11/14/97	Plan revised to indicate pedestrian and bicycle safe grate GDI's.
DATE	REVISION
STATE OF HAWAII DEPARTMENT OF TRANSPORTATION HIGHWAYS DIVISION	
DRAINAGE PLAN	
VOLCANO RD. DRAINAGE IMPROVEMENTS	
Vicinity of Keau Town	
F.A. Proj. No. STP-011-2(30)	
Scale: 1"=40'	Date: Oct 1997
SHEET No. <i>HI</i> OF 6 SHEETS

DRAINAGE DETAILS
VOLCANO RD. DRAINAGE IMPROVEMENTS
Vicinity of Keaau Town
F.A. Proj. No. STP-011-2(30)
Scale: 3/4" = 1'-0"
Date: Oct 1997

STATE OF HAWAII DEPARTMENT OF TRANSPORTATION HIGHWAYS DIVISION
DRAINAGE DETAILS
VOLCANO RD. DRAINAGE IMPROVEMENTS Vicinity of Keaau Town F.A. Proj. No. STP-011-2(30)
Scale: 3/4" = 1'-0" Date: Oct 1997
SHEET No. H4 OF 6 SHEETS

GRATE

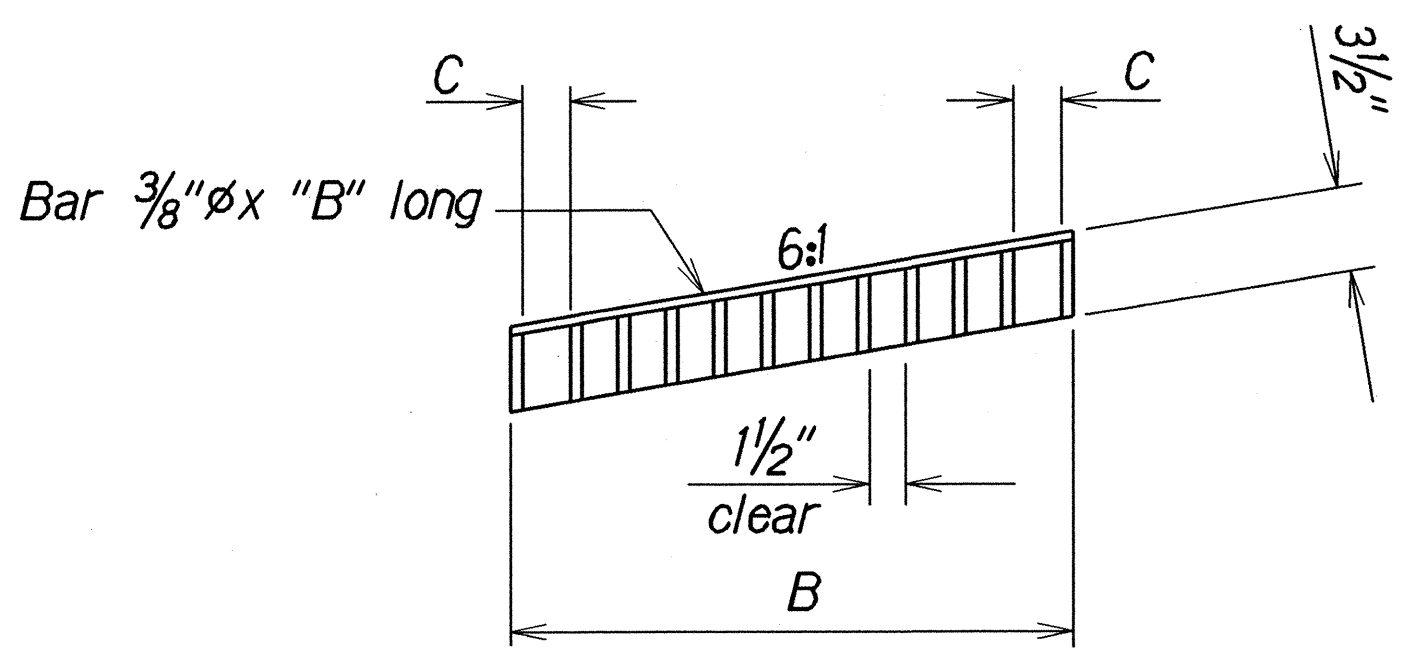
11/14/97	Sheet added to show details of pedestrian and bicycle safe frame & grates.
DATE	REVISION
STATE OF HAWAII DEPARTMENT OF TRANSPORTATION HIGHWAYS DIVISION DRAINAGE DETAILS VOLCANO RD. DRAINAGE IMPROVEMENTS Vicinity of Keaau Town F. A. Proj. No. STP-011-2(30) Scale: 1 1/2" = 1'-0" Date: Nov. 1997 SHEET No. H6A OF 6 SHEETS
